NONMANDATORY APPENDIX G FRACTURE TOUGHNESS CRITERIA FOR PROTECTION AGAINST FAILURE

It is proposed to add the following paragraph. This paragraph is an alternative risk-informed procedure to the current Paragraph G-2215, which provides a deterministic procedure to determine the allowable pressure temperature curves for Level A and Level B Service Limits. The following paragraph essentially duplicates G-2215 except it uses risk adjusted margins instead of deterministic margins as shown by “Track Changes”.

G-2216 Risk-informed Allowable Pressure

Fig. G-2216-1

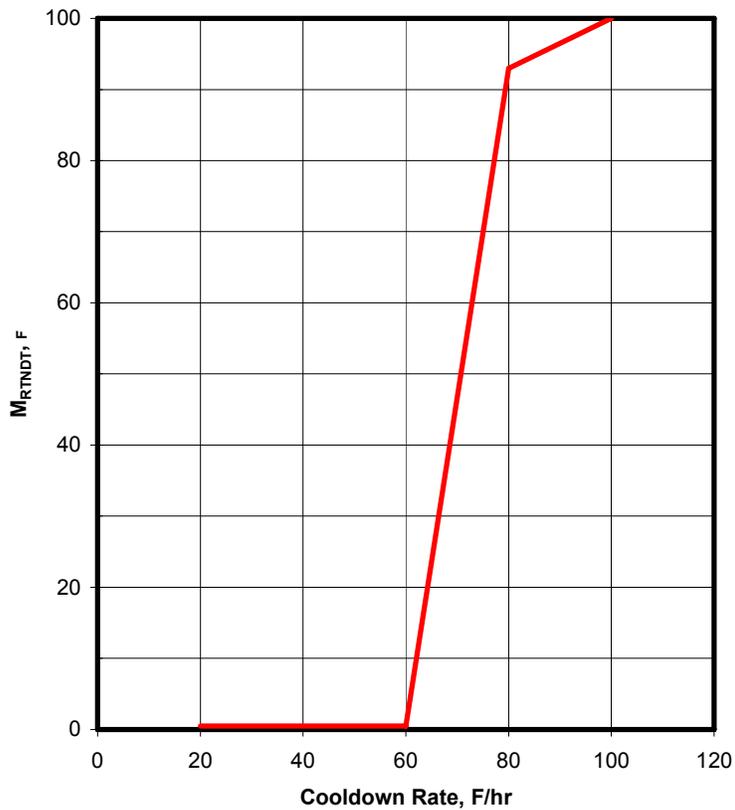
M_{RTNDT} is a risk adjusted factor applied to K_{IC} and is determined from Fig. G-2216-1.
